E5070B-12C

S E R V I C E N O T E

E5070B RF Network Analyzer, 300kHz to 3 GHz

When E5070B has the old step attenuator (33321-60059) and fails Internal Test at Step Attenuator test group, replace the old step attenuator (33321-60059) by improved version (33321-60068), add additional cable and update firmware to 5.02 or later

Figure 1 Make A7 assembly (for option 214 & option314/414 with 1 attenuator)

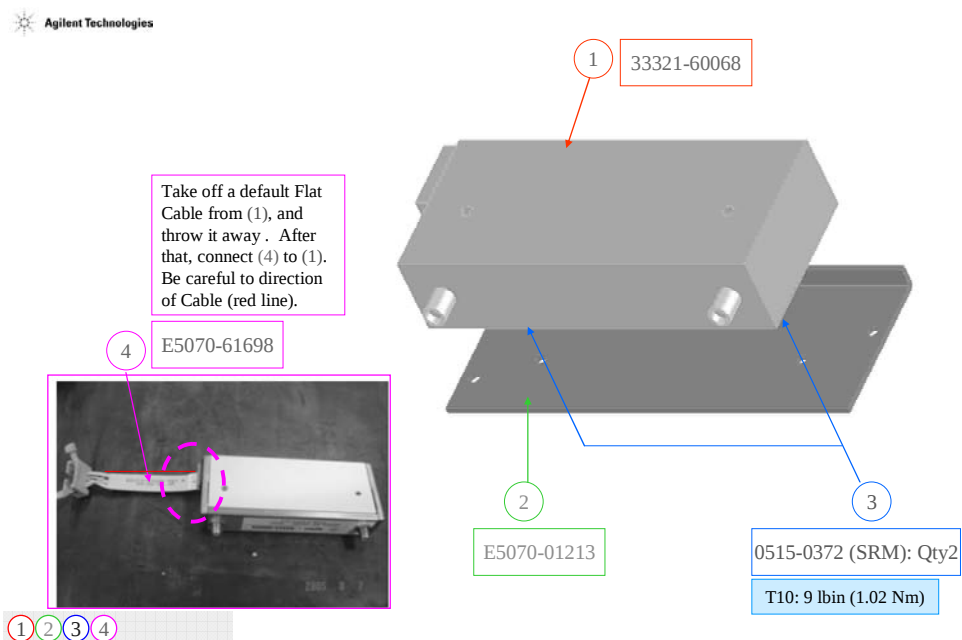
1. Disassemble the product. (Refer to E5070B/E5071B Service manual chapter 6 for details)
2. Make A7 step attenuator assembly by 33321-60068 (1ea), E5070-61698 (1ea), E5070-01213 (1ea), 0515-0372 (2ea) and E5070-61617 (1ea). E5070-61698 is the cable between 33321-60068 and E5070-61617. Scrap 33321-60059.
- 2-1. Scrap the flat cable that comes with the new attenuator (33321-60068).
- 2-2. Connect E5070-61698 to 33321-60068.
- 2-3. Connect E5070-61698 to E5070-61617.

**Figure 2 Install A7 attenuator assembly (1)**

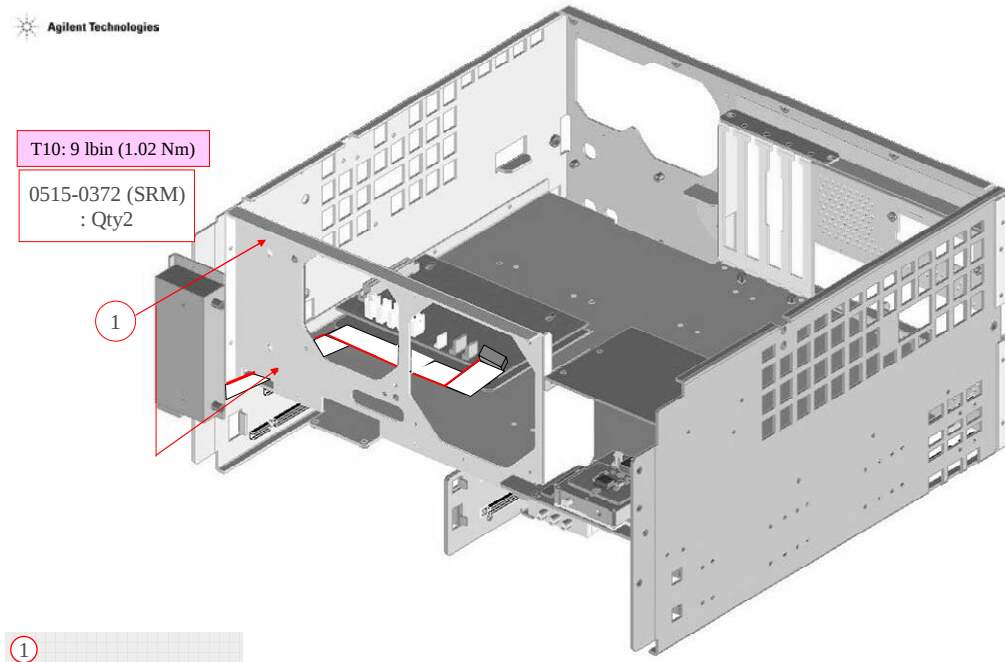
3. Install A7 assembly with 0515-0372 (2ea).

**Figure 3 Install A7 attenuator assembly (2)**

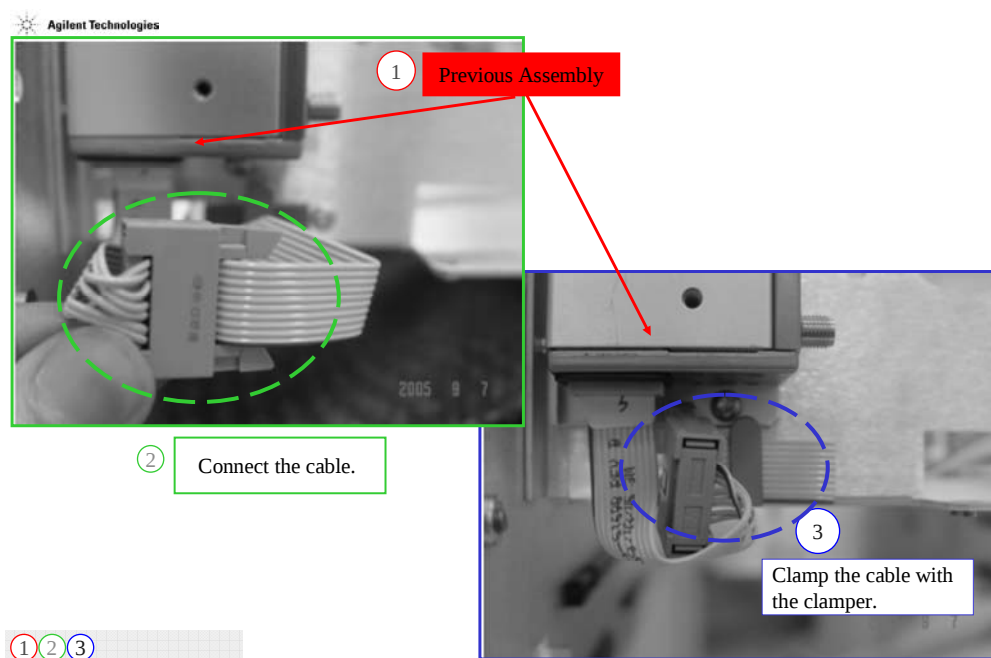
4. Connect the cable and clamp the cable with the clumper. Be careful to flat cable direction and its connectivity.

Figure 4 Make A7 assembly (for option 314/414 with 2 attenuators)

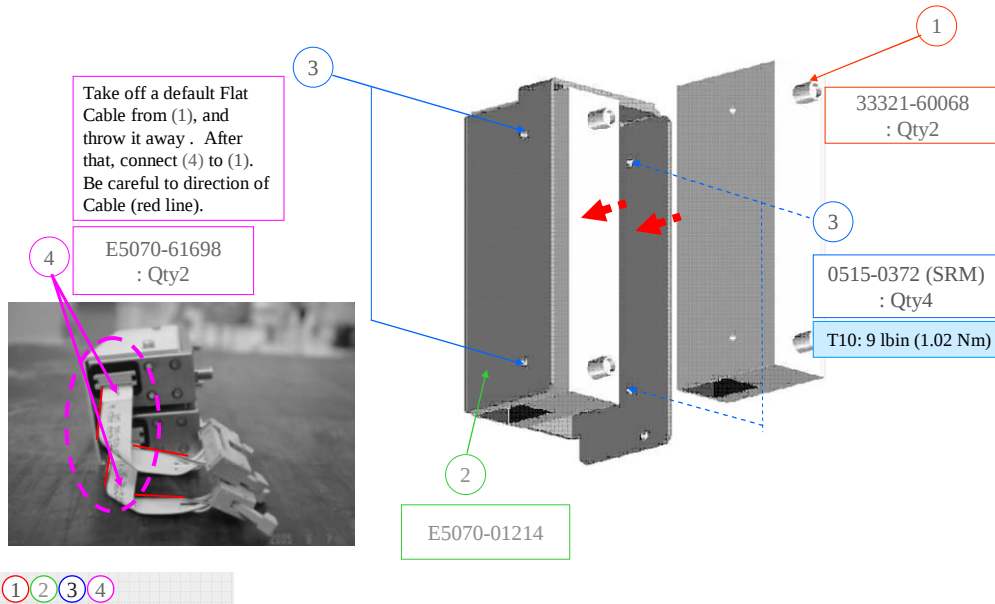
1. Disassemble the product. (Refer to E5070B/E5071B Service manual chapter 6 for details)
2. Make A7 step attenuator assembly by 33321-60068 (2ea), E5070-61698 (2ea), E5070-01214 (1ea), 0515-0372 (4ea) and E5070-61618 (1ea). 2ea of E5070-61698 are the cable between 33321-60068 and E5070-61618. Scrap 33321-60059.
- 2-1. Scrap the flat cable that comes with the new attenuator (33321-60068).
- 2-2. Connect E5070-61698 to 33321-60068. (This is done twice)
- 2-3. Connect E5070-61698 to E5070-61618.

**Figure 5 Install A7 attenuator assembly (1)**

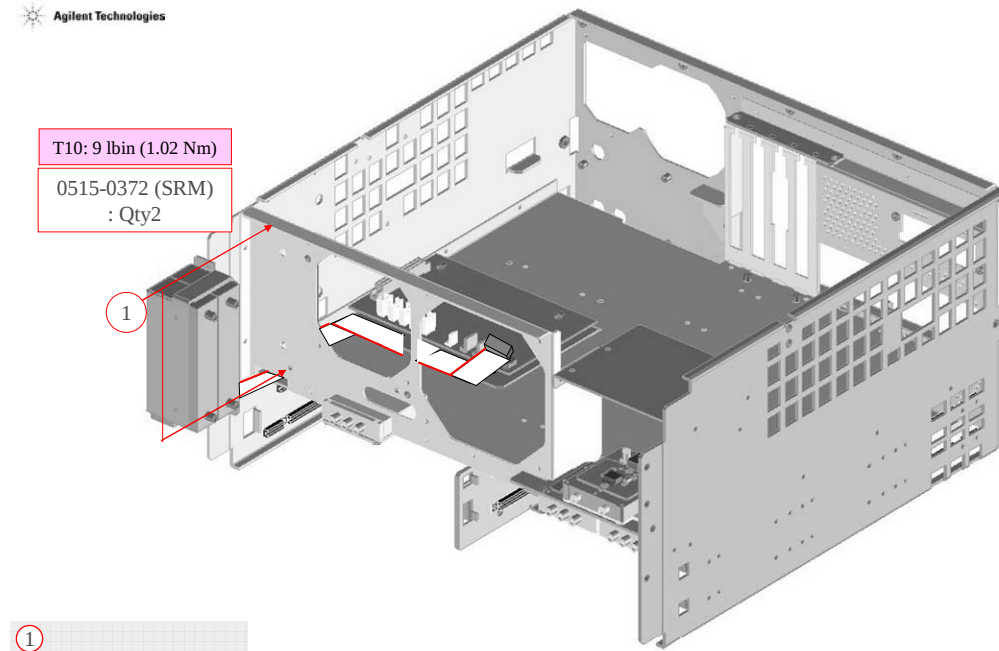
3. Install A7 assembly with 0515-0372 (2ea).

**Figure 6 Install A7 attenuator assembly (2)**

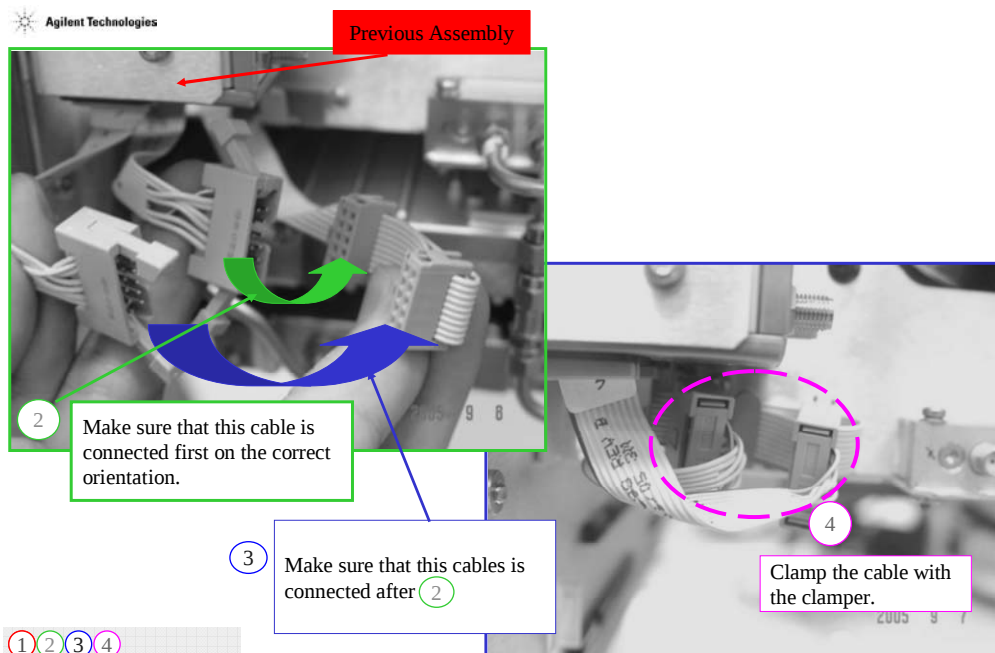
4. Connect the cable and clamp the cable with the clamber. Be careful to flat cable direction and its connectivity.
